ADDENDUM NUMBER 1:
NEW HAMPSHIRE COOPERATIVE RECYCLING FACILITY
CONTRACT DOCUMENTS AND TECHNICAL SPECIFICATIONS

Issued: May 20, 2009
For Bids Due: May 27, 2009

CSK-1

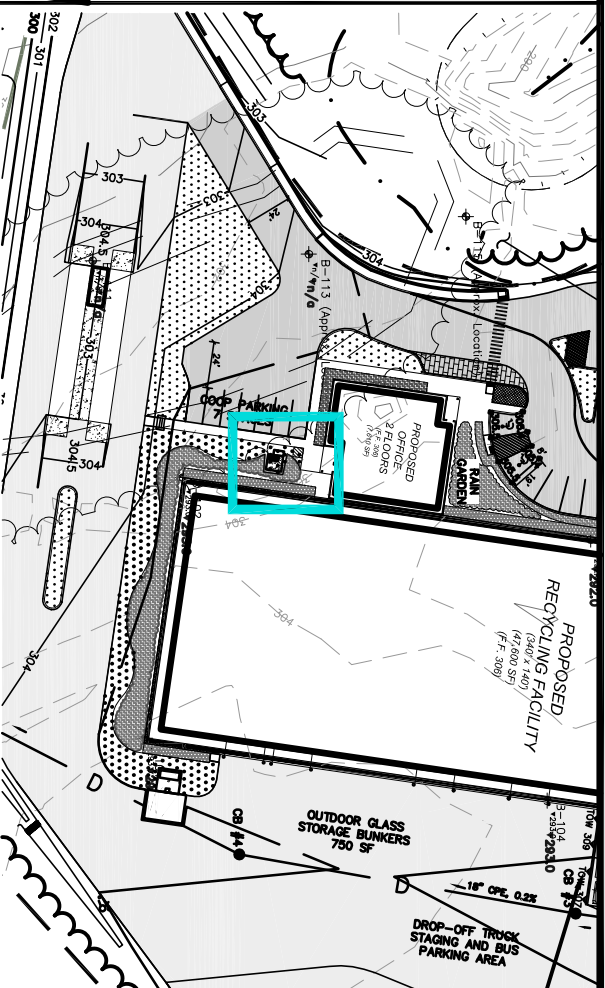
- a. Include an additional 5' x 5' section of concrete pavement as shown on the attached Sketch CSK1 to adjust the sidewalk area to coordinate with the columns of the canopy roof over the door entrance to the office.

1. This site sketch depicts a 5' x 5' concrete pavement section added to the plans and as described in Addendum #1 to the the New Hampshire Cooperative Recycling Facility Construction Drawings.
2. The additional concrete section shall conform to the concrete pavement detail shown on Sheet L-3 of the Landscape Drawings.

SSK1

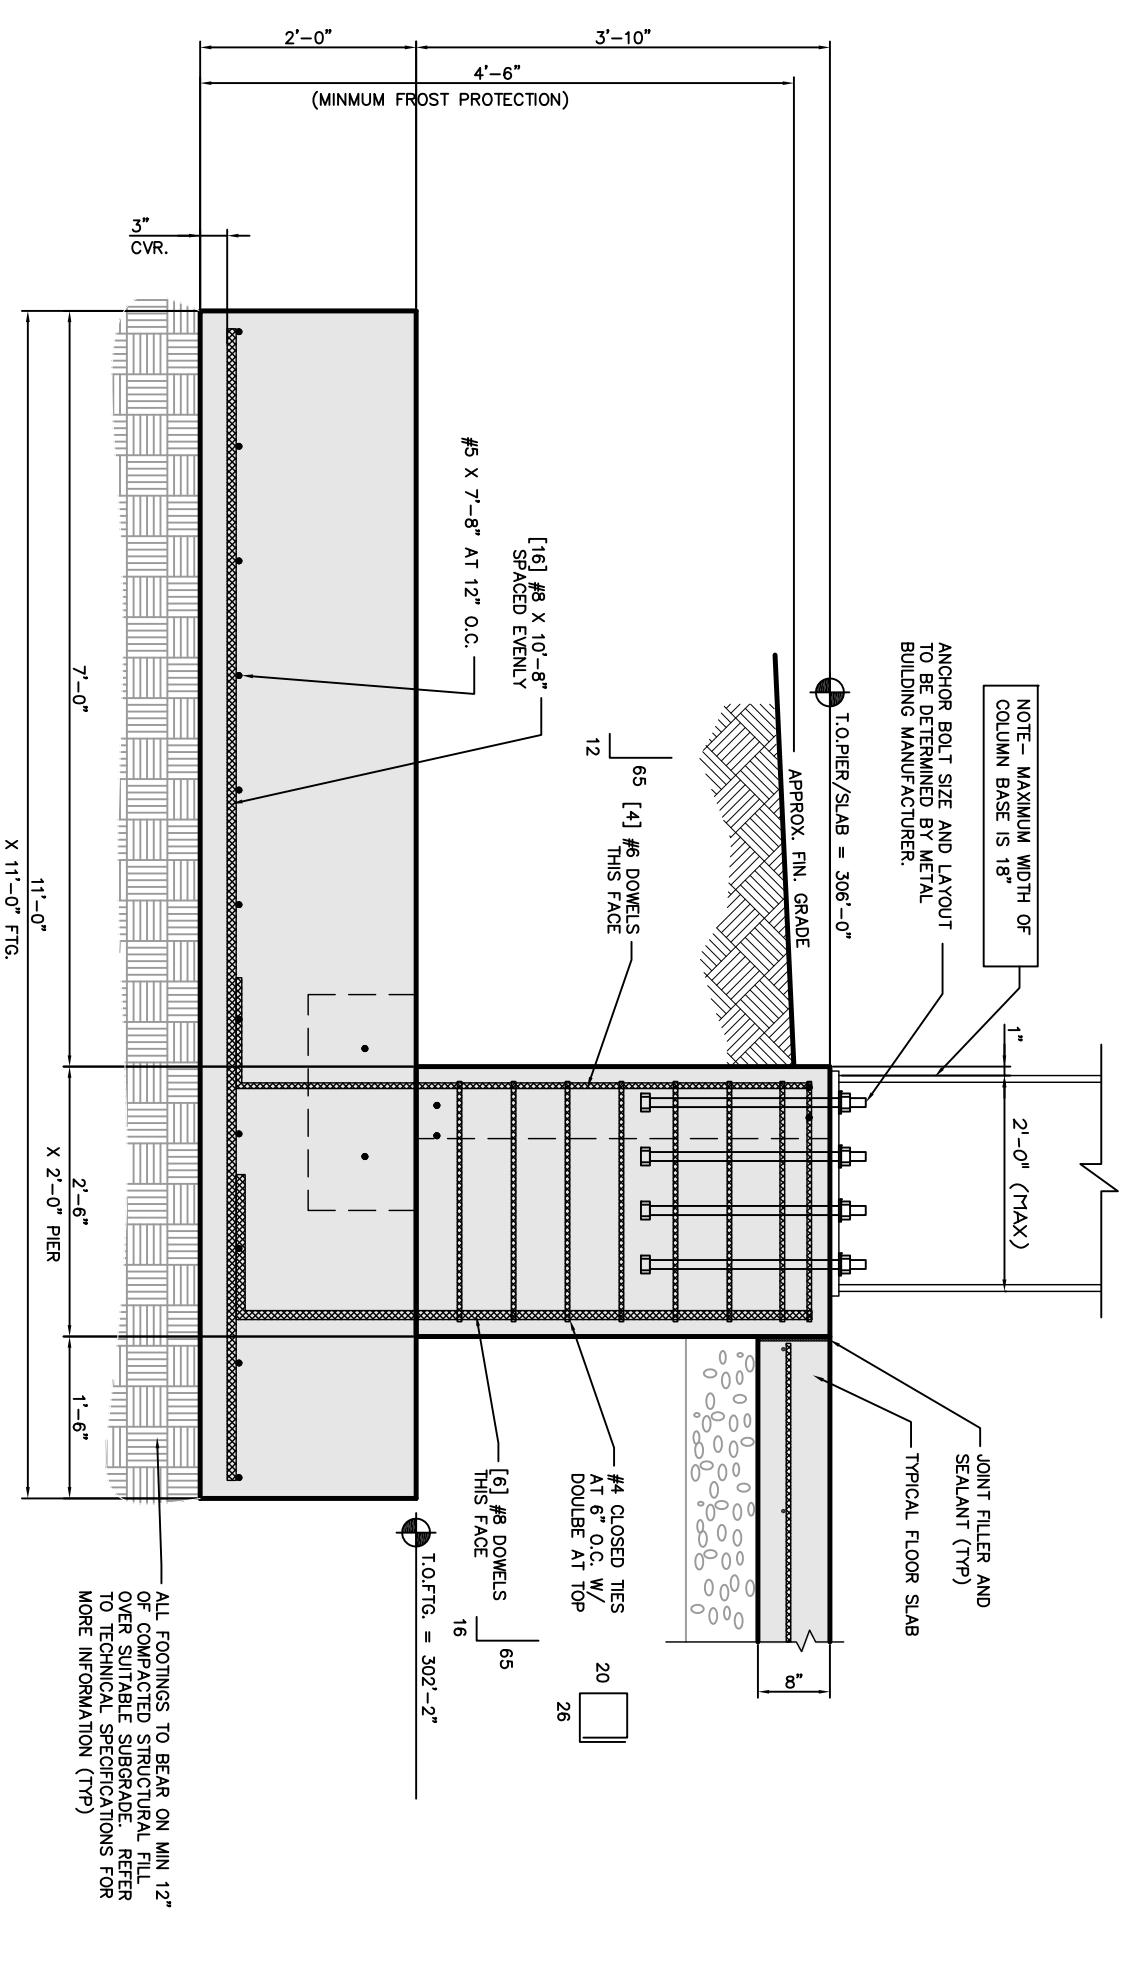
- a. Sketch SSK1 is attached to provide a section through the spread footing at column line H5.
- b. Sketch SSK2 is attached to provide a detail through the open section at the slab on grade and foundation level at column line F for where the push wall is dropped for the overhead and personnel door openings.
- c. Revise the heights depicted on Detail 3 – Metal Building Frame Dimensions to indicate “39’ Finished Eave” and “33’ Clear”.
- d. Revise Note 5 of the Metal Building Notes to Read as Follows:
